Product / Process Change Notification (PCN)							
<input checked="" type="checkbox"/> Major Change <input type="checkbox"/> Minor Change							
PCN Number: PCN_WPME-FDSM_20241118 Affected Series: WPME-FDSM Affected Order Codes: 173950536 PCN Date: 2024-10-18 (YYYY-MM-DD) Effective Date: 2024-11-18 (YYYY-MM-DD)	Change Category: <input checked="" type="checkbox"/> Equipment/Location <input checked="" type="checkbox"/> General Data <input checked="" type="checkbox"/> Material <input type="checkbox"/> Process <input checked="" type="checkbox"/> Product Design <input checked="" type="checkbox"/> Shipping/Packaging <input checked="" type="checkbox"/> Supplier <input type="checkbox"/> Software						
Contact: Product Management Phone: +49 (0) 7942 - 945 5001 Fax: +49 (0) 7942 - 945 5179 E-Mail: pcn.eisos@we-online.com	Datasheet Change: <input checked="" type="checkbox"/> Yes <input type="checkbox"/> No Attachment: <input checked="" type="checkbox"/> Yes <input type="checkbox"/> No						
Description of Change: <p>Due to an improvement of the production capability, Würth Elektronik eiSos has shifted the production of the affected order codes to a new factory location.</p> <p>With the aim of

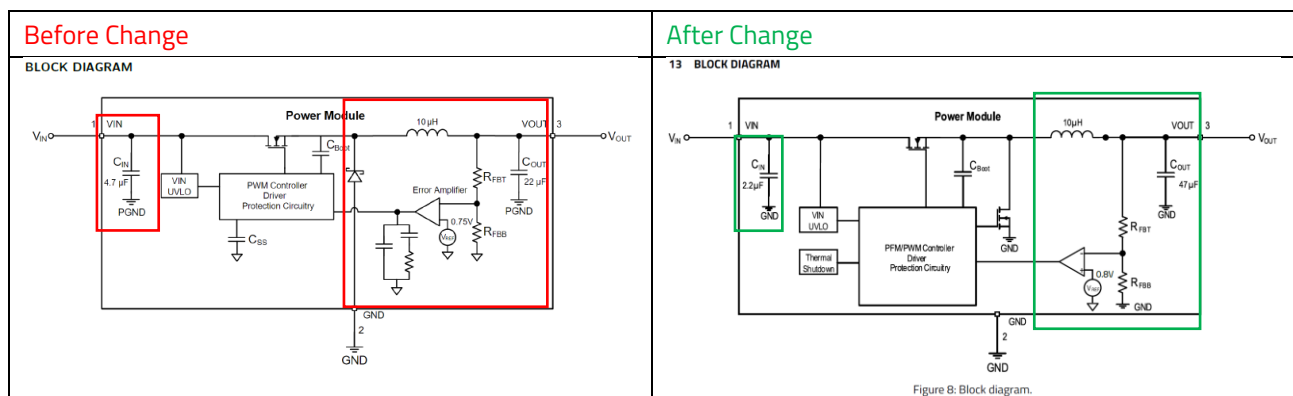
The diagrams shown in chapter TYPICAL PERFORMANCE CURVES are updated based on new electrical specifications. The used test conditions stay the same as before.

Due to the change of the integrated IC, the internal BOM is changed. The changes in component values and new internal reference voltage are indicated in the BLOCK DIAGRAM chapter.

Before Change

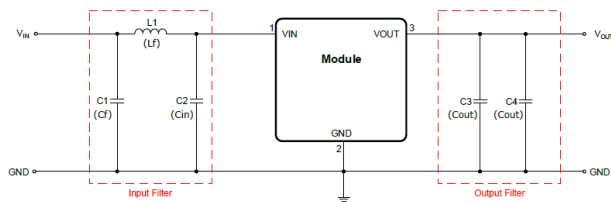
The EMI filter components in the design example have been updated to match the MLCC filter components shown in the EMI graph chapter. The polymer capacitor-based filter from the previous datasheet, version 3.0, has been verified to still fulfill the CISPR-32 limits.

The 17395xx36 family integrates both the input and output capacitors. It is also recommended to use two 10µF input capacitors for 173950336 and 173950536 or four 4.7µF input capacitors for 173951236 and 173951536, C1 and C2, for high impedance input wires or traces and two 10µF output capacitor, C3 and C4, for applications where a low output voltage ripple is required.

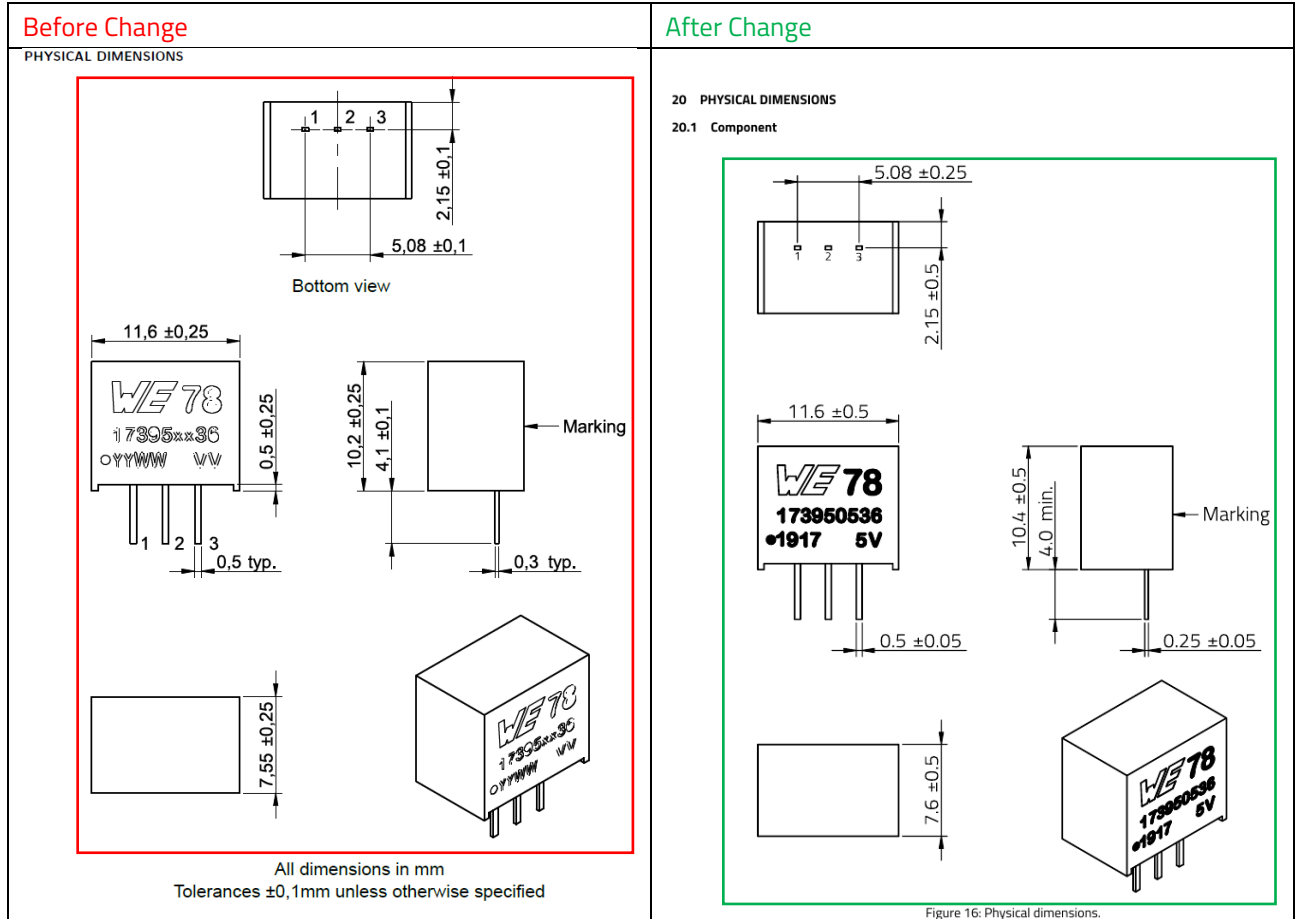
The mechanical dimensions have been updated based on new production. The SIP-3 land pattern will remain the same and the device dimensions and tolerances have changed slightly.

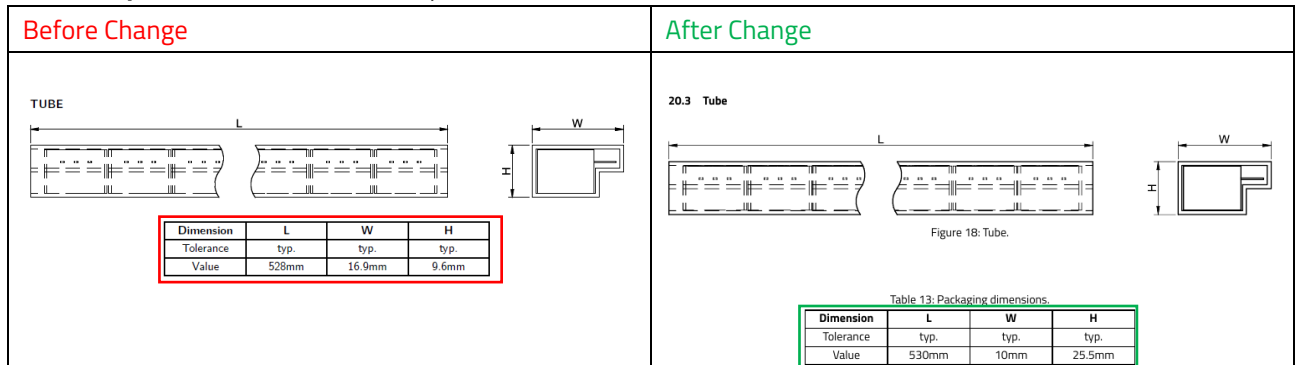
The tube specifications have been adjusted.
